Service Info

Renault** - 228 0073 11 - 280/280 TGU6

New design / Neues Design / Nouvelle conception / Nuevo diseño / Nuovo disegno

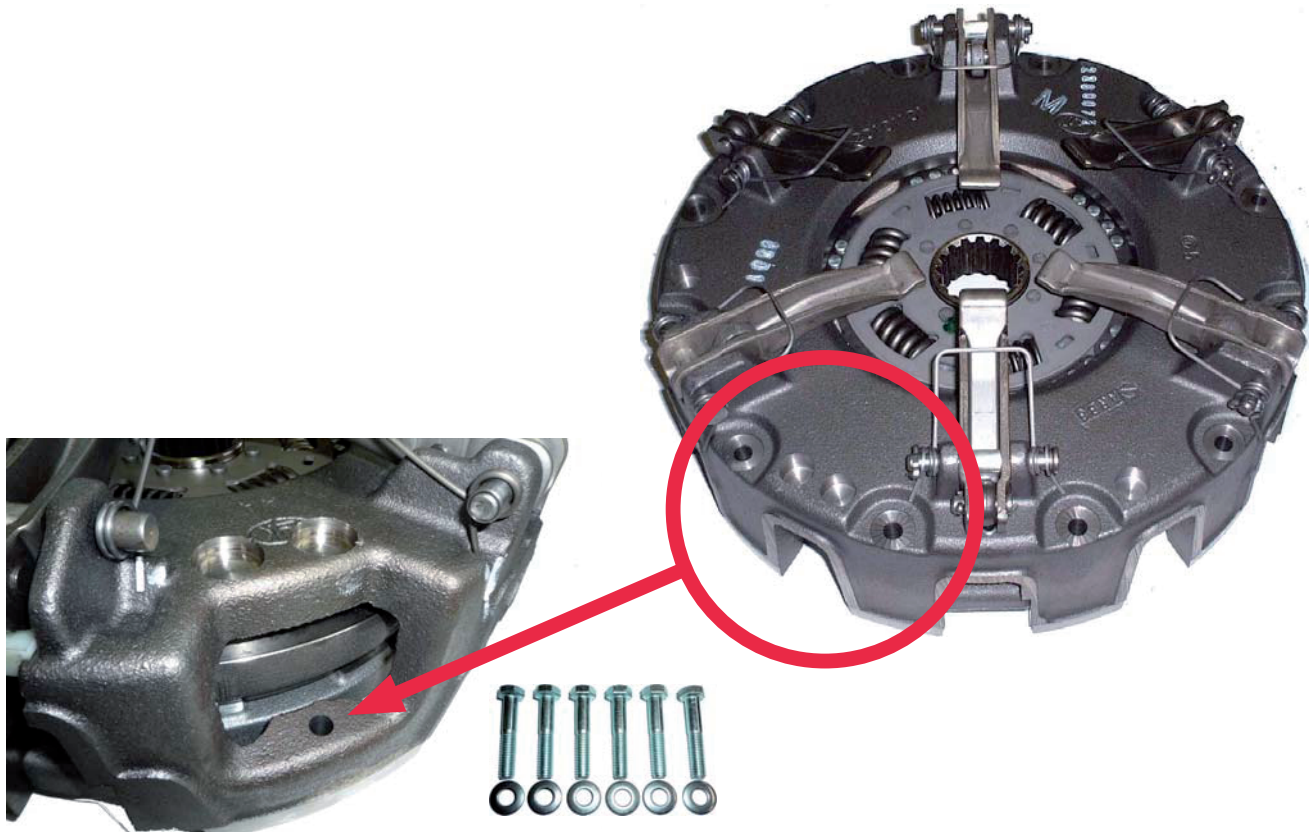
This new design utilises the latest clutch technology, using a vented housing for improved cooling and heat dispersal.

Fully interchangeable with existing clutches with no modifications required to vehicle or flywheel.

New fixation bolt set 6 x M8 x 1.25 x 50mm is supplied with new designs to accommodate the lower housing.
